BELLEWOOD SUBDIVISION

APPLICATION NUMBER 7 DATE June 15, 2017

REQUEST Subdivision

DETAIL SITE PLAN

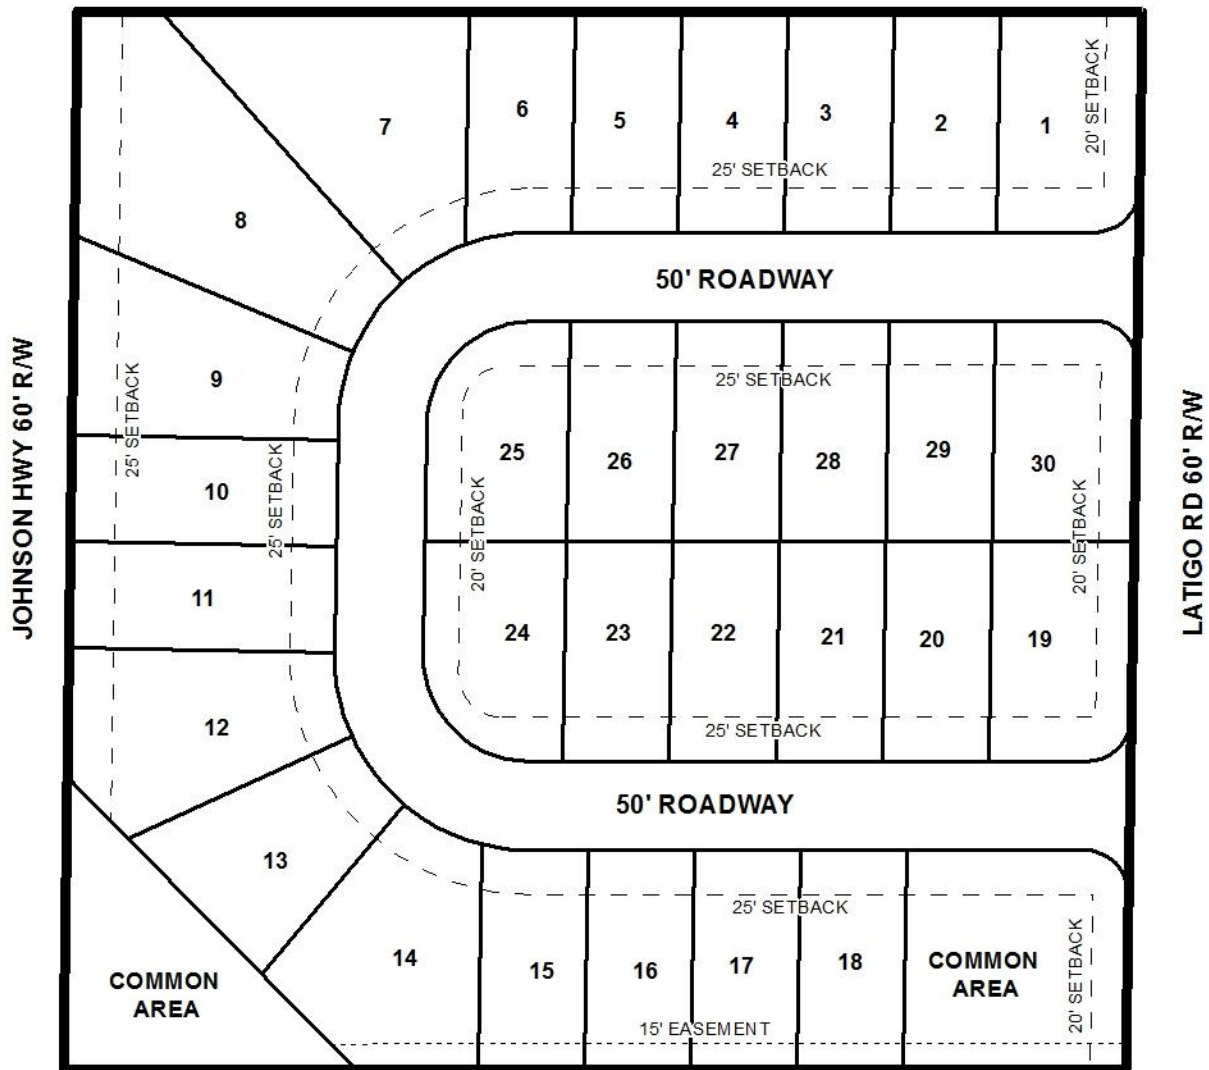
The plat indicates only a 20' minimum building setback line along Latigo Road, and for Lots 24 and 25 in the interior of the site. No justification for reduced setbacks as they pertain to an innovative subdivision has been provided. Therefore, the plat should be revised to illustrate the 25' minimum building setback line along all street frontages.

Access management is a concern along Latigo Road; therefore, a note should be required on the Final Plat, if approved, stating that Lots 1, 19, 30 and the Southeastern Common Area are denied access to Latigo Road. The plat does not indicate any designated access to the Southwestern Common Area; therefore, the plat should be revised to provide dedicated access to the Southwestern Common Area. This will require a 25' road frontage along the proposed street and may require the relocation of the 25' minimum building setback line on some lot(s) so as to be located where the lot(s) can be at least 60' wide at the setback line. All lots and the Common Areas should be limited to one curb cut each, with the size, location and design to be approved by Mobile County Engineering and conform to AASHTO standards.

Lots are labeled with their areas in square feet only. Therefore, the plat should be revised to label each lot with its size in both square feet and acres, or a table should be furnished on the Final Plat providing the same information.

The site has property lines at an intersection corner. Section V.D.6. of the Subdivision Regulations requires that "property lines at street intersection corners shall be arcs having radii of at least 10 feet or shall be chords of such arcs." As no curve data is provided for these entrances, the plat should be revised to indicate compliance with the Section V.D.6. Curve data is provided on the plat for three curves, but there is no corresponding identification of the specific curves. Therefore, the plat should be revised to identify the location of the curves for which the data is provided.

A 15' drainage easement runs along the South side of the subdivision. Therefore, a note should be required on the Final Plat stating that no structure may be placed or constructed within this easement.

- 1) revision of the plat to illustrate a 25' minimum building setback along all street frontages for all lots;
- 2) revision of the plat to provide a 25' dedicated access to the Southwestern Common Area;
- 3) possible revision of the plat to ensure the building setback line is located at a point where lots are at least 60' wide for any lot(s) revised to provide the 25' frontage for the Southwestern Common Area;
- 4) revision of the plat to provide curve data for the subdivision entrance curves in compliance with Section V.D.6. of the Subdivision Regulations; and
- 5) revision of the plat to provide identification of the three curves for which curve data is given.
